Subject: FTF Comments on Integrated Assessment
Date: Wednesday, August 08, 2012 9:45:48 AM
Attachments: [Integrated Assessment, Draft a.FTF comments.pdf](#)
[Comments on IA - 08-07-12-FTF.doc](#)

**Guidance for Performing the Integrated
Assessment for Flooding**

DRAFT Interim Staff Guidance

**DRAFT
INTERIM STAFF GUIDANCE
JAPAN LESSONS-LEARNED PROJECT DIRECTORATE
GUIDANCE FOR PERFORMING THE INTEGRATED ASSESSMENT FOR
EXTERNAL FLOODING
JLD-ISG-12-##**

Figure 1: Illustration of graded approach

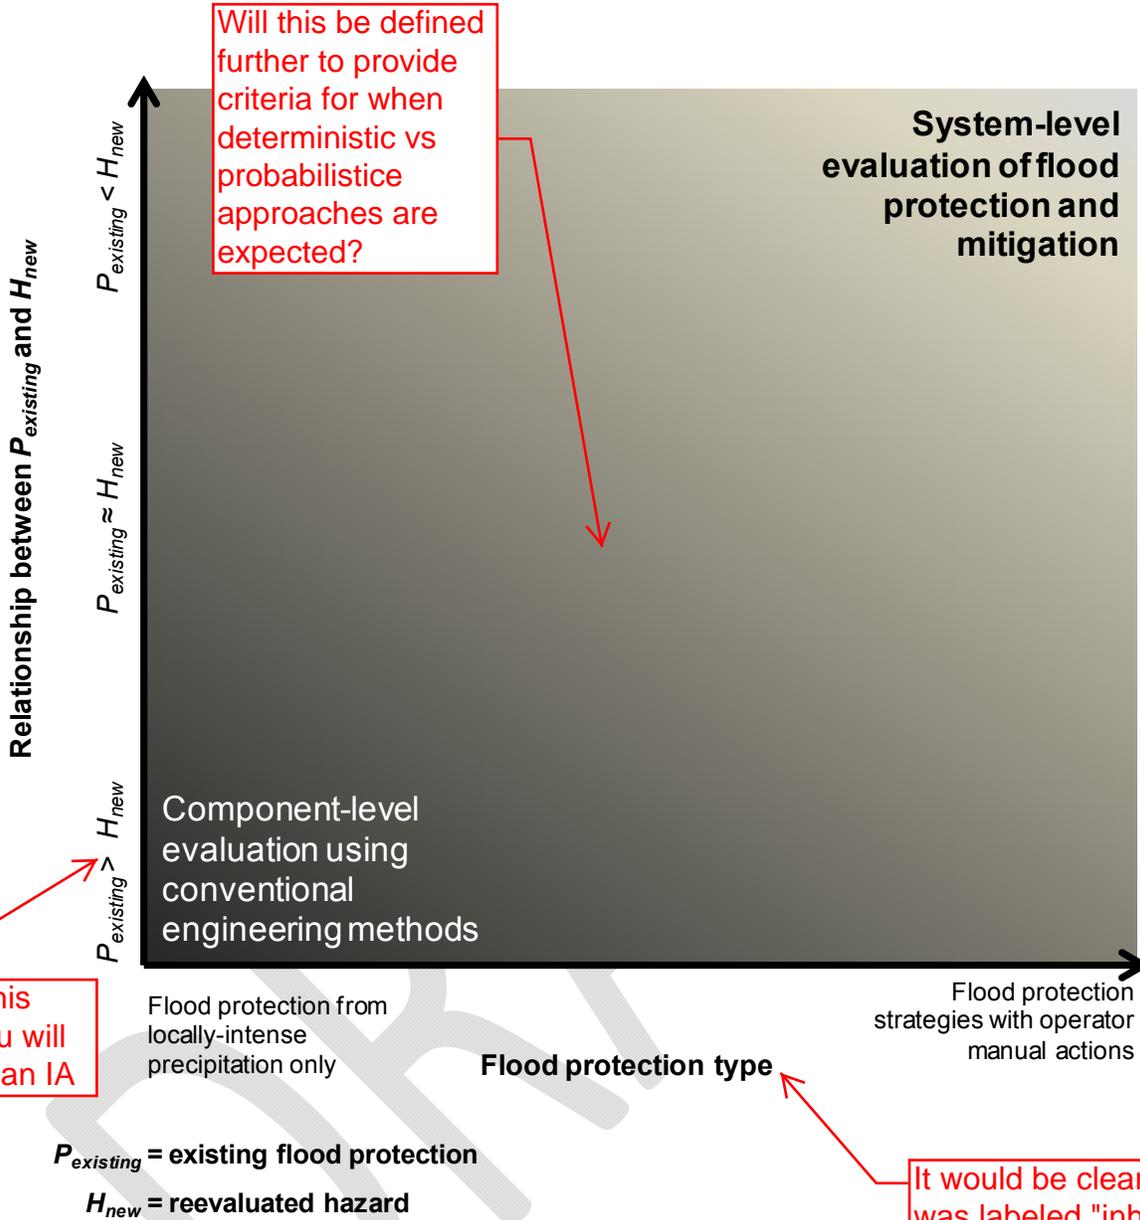
Will this be defined further to provide criteria for when deterministic vs probabilistic approaches are expected?

Figure 2: Evaluation flowchart

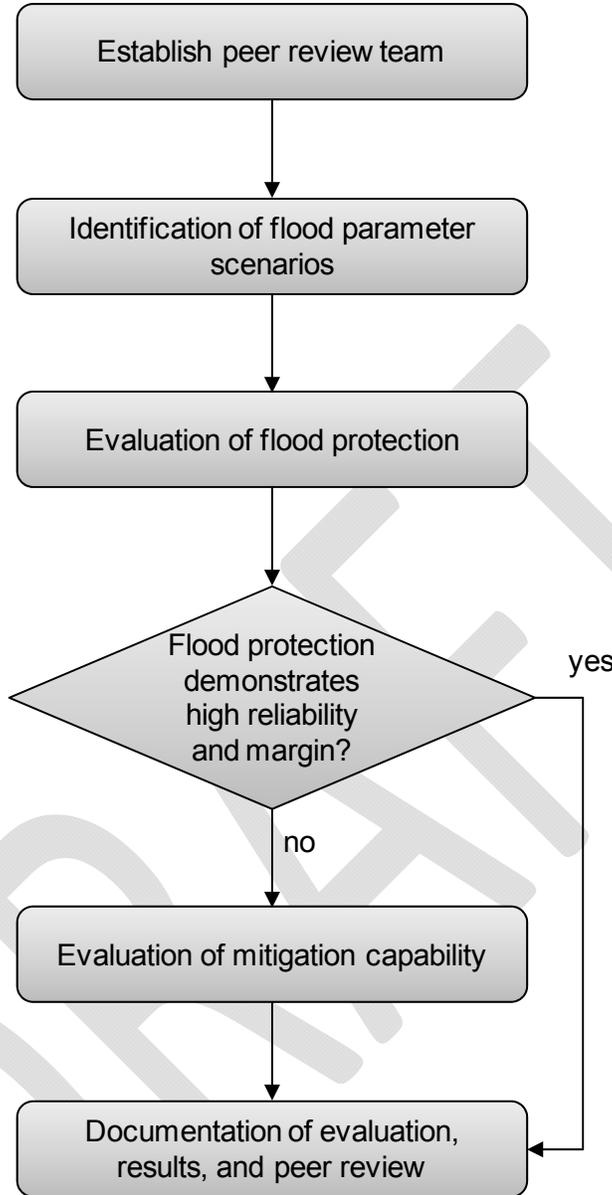
Why are app B controls not sufficient? This could get resource intensive if a number of plants have to perform this at the same time.
